CITY OF ALBUQUERQUE

RE: **Lot 7 Block 7 SAD 227**
Unser Cliffs
7911 Kibo NW
Grading and Drainage Plan
Engineers Stamp Date 3/28/19 (E10D060)

DRAINAGE AND TRANSPORTATION INFORMATION SHEET (REV 6/2018)

| | GRADING AND DRAINAGE PLAN | DATE: 3-28-19 |

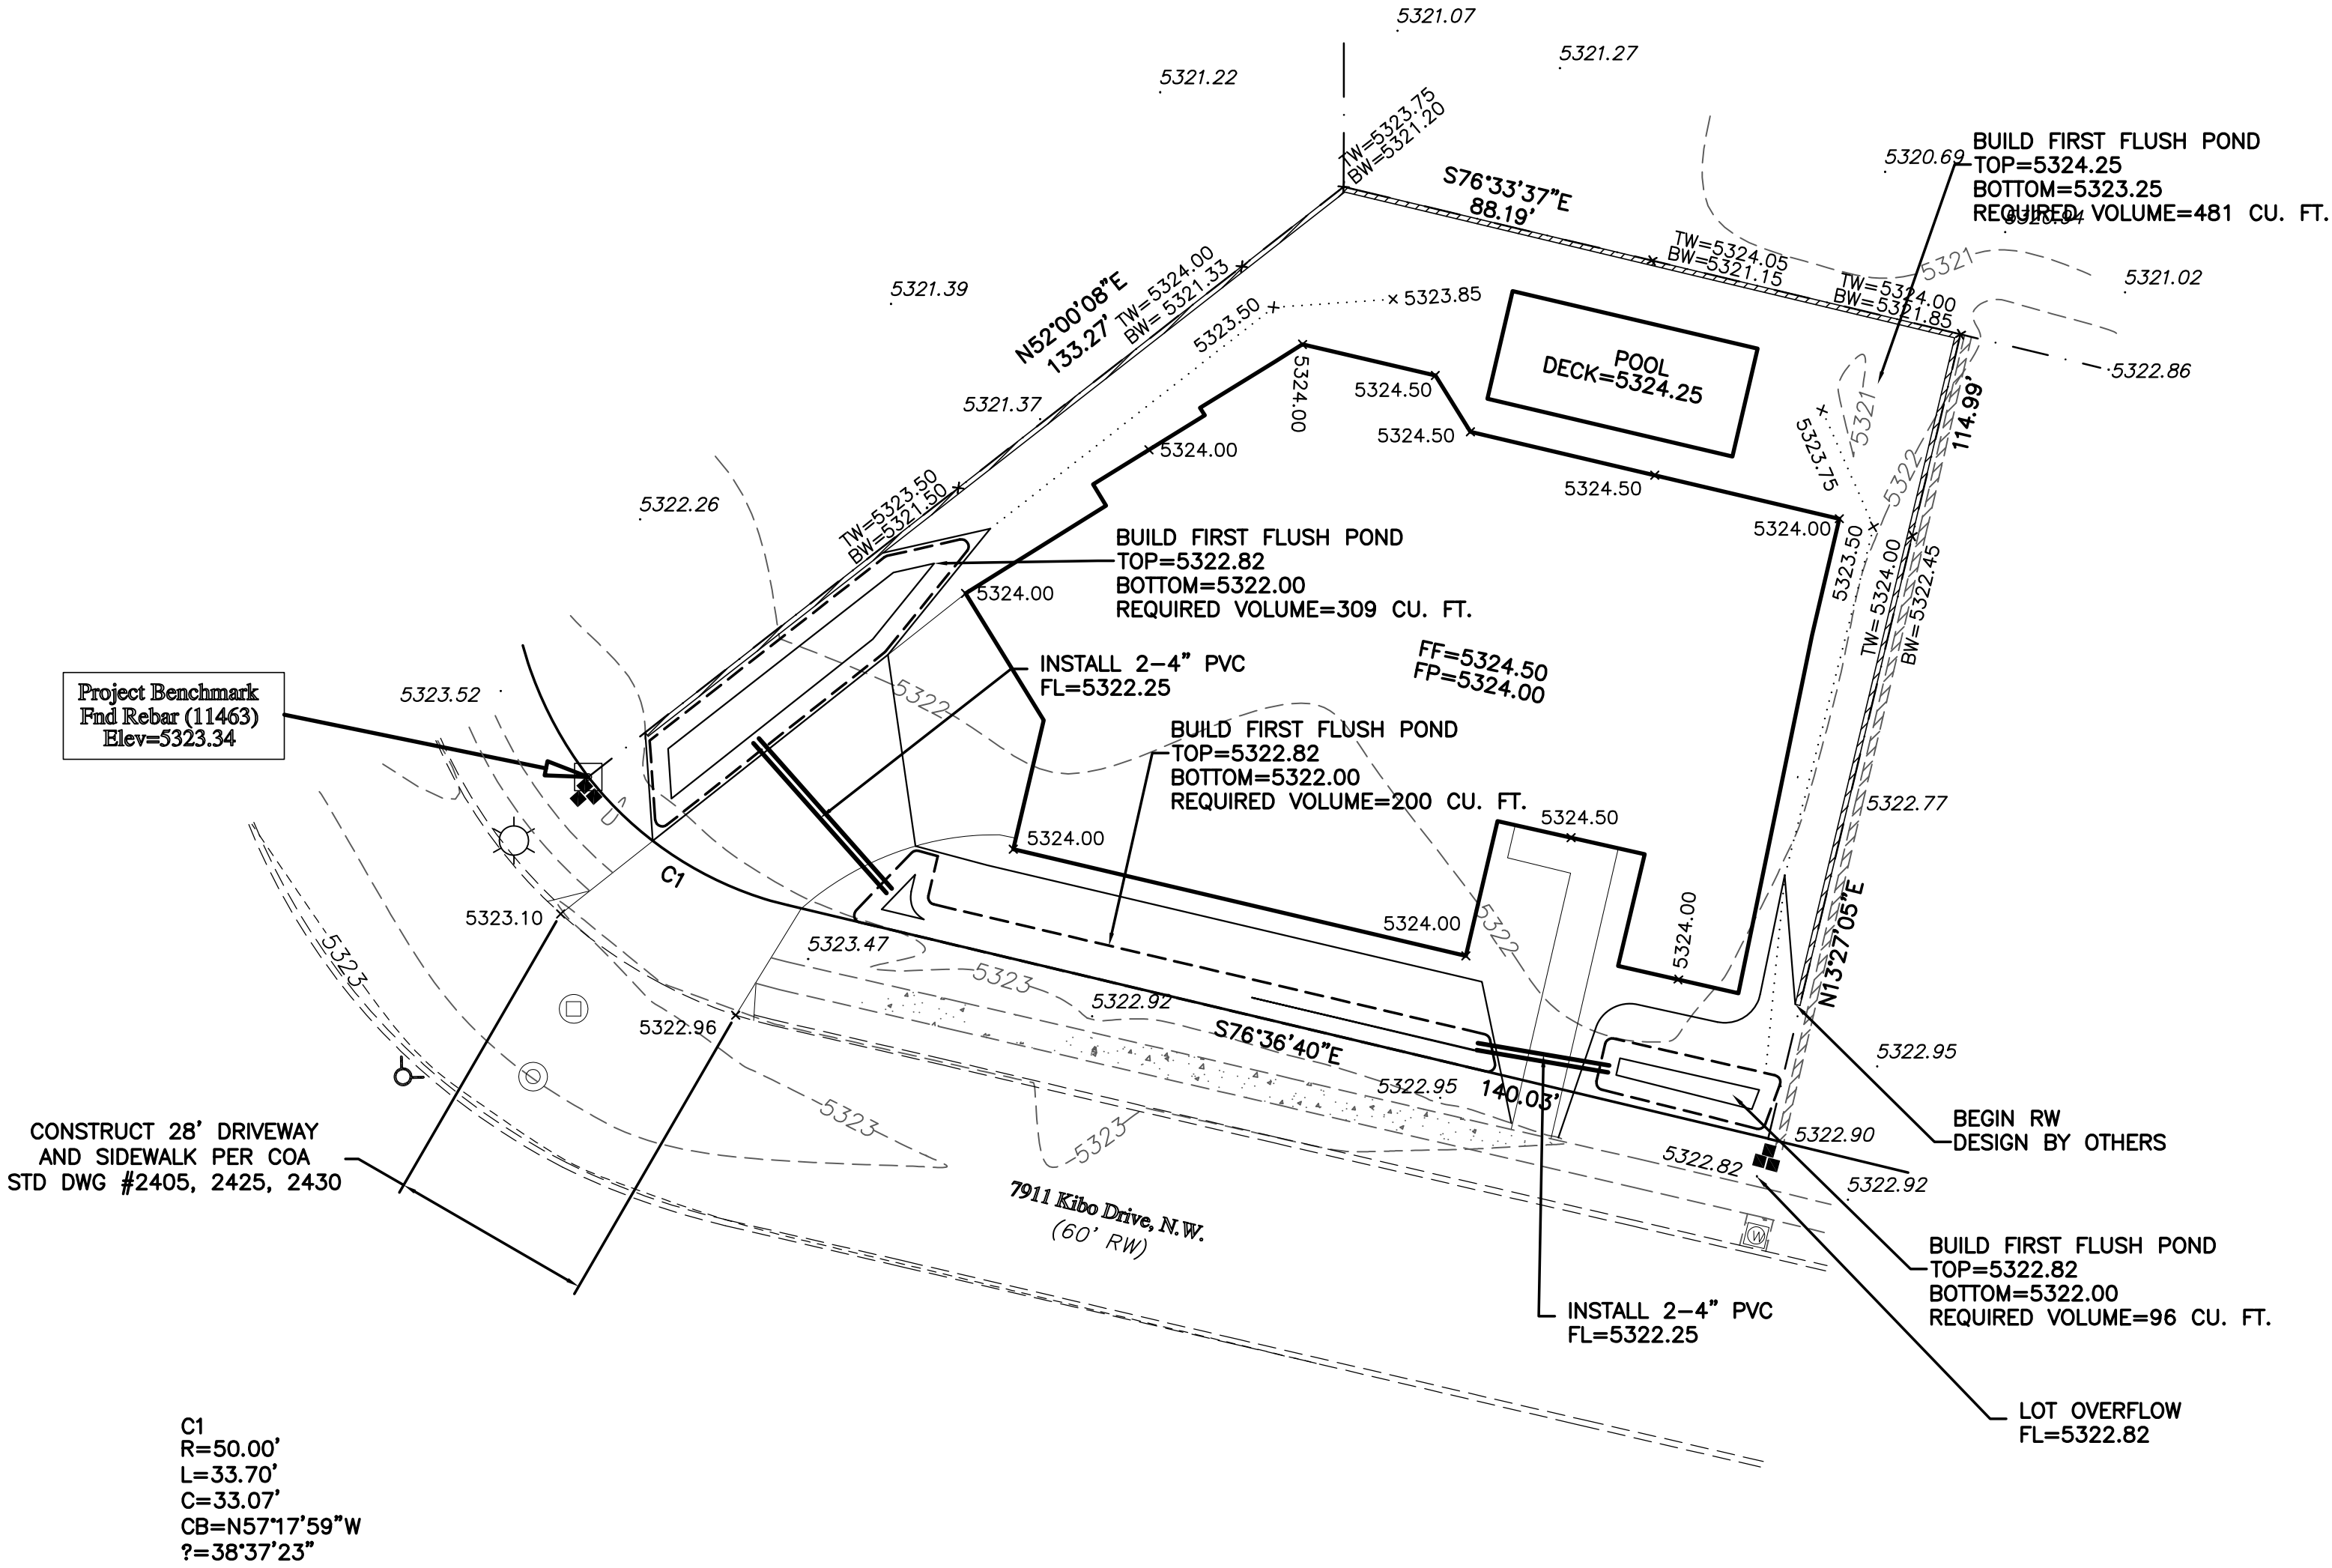
- Provide a detention pond for the site. The percentage required is 34%, the amount of D provided is 58%, the pond must contain the difference which is 24%.
